PROJECT KL2A NOTE Calpella DIS Quanta Computer Inc.								
Size Document Number Custom FRONTPAGE		Rev 1A						
Date: Monday, November 23, 2009	Sheet 2 o	of 50						
7	8

KL2A Schematic EC Tracking Record A (for SIV)Mar. 11, 2009

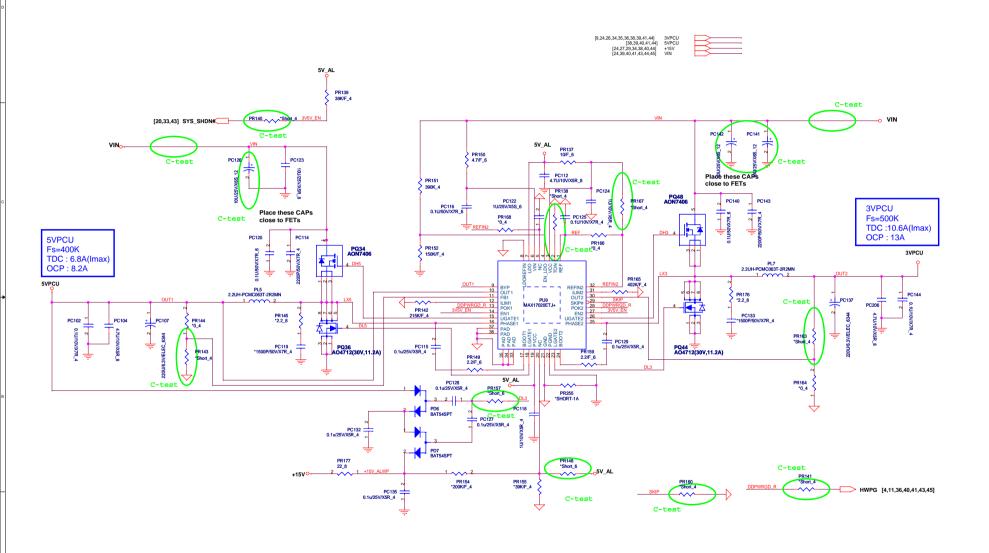
R138=0.02m ohm for 65W adapter-->current limit is 3A;
